LA PAZ COUNTY PUBLIC WORKS

As per our discussion, I will allow a low water crossing to be built in the Tyson Wash on 53rd Street with the following stipulations:

53rd Street, Tyson Wash crossing

**LA PAZ COUNTY
CONSTRUCTION STANDARDS
STANDARD No 5-380
CONCRETE CUT-OFF WALLS**

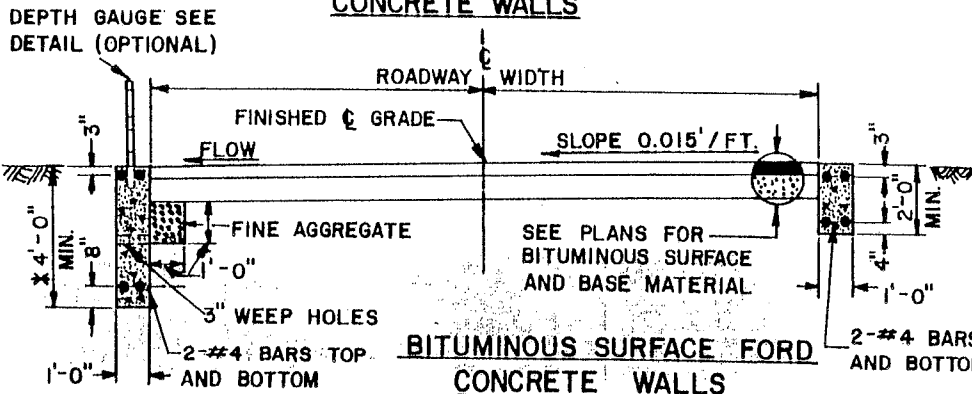
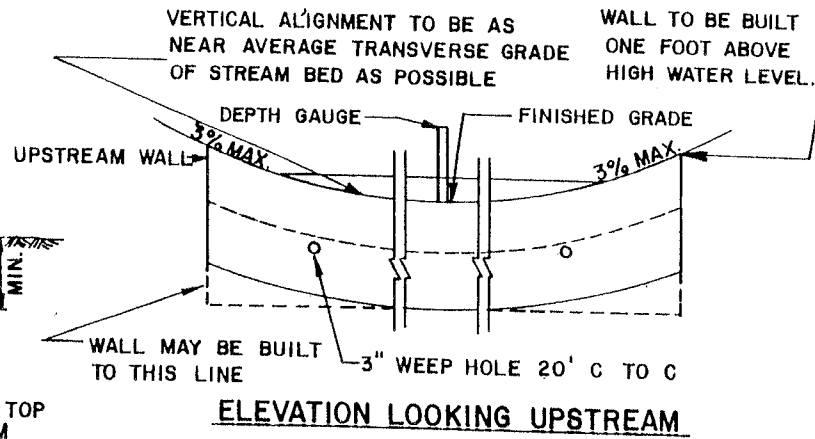
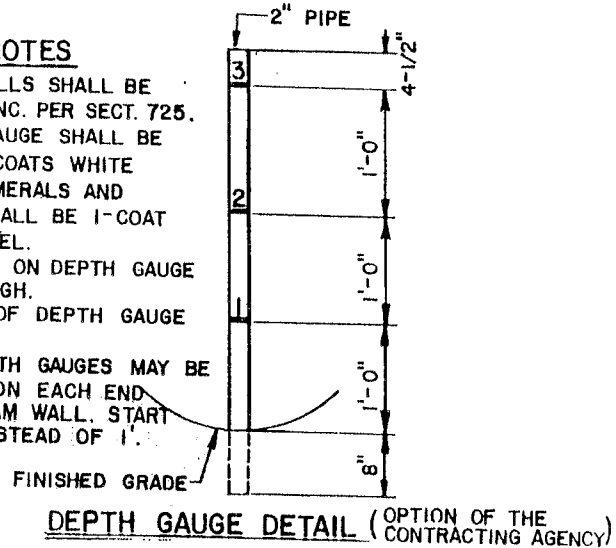
- You obtain a 404 Permit from the Army Corp. of Engineers.
- You follow the La Paz County Standards, Standard #5-380 Concrete Cut-Off Walls with the Concrete Surface Ford.
- Have it surveyed and engineered for a vertical alignment and to determine where the 1 (one) foot above high water level would be.
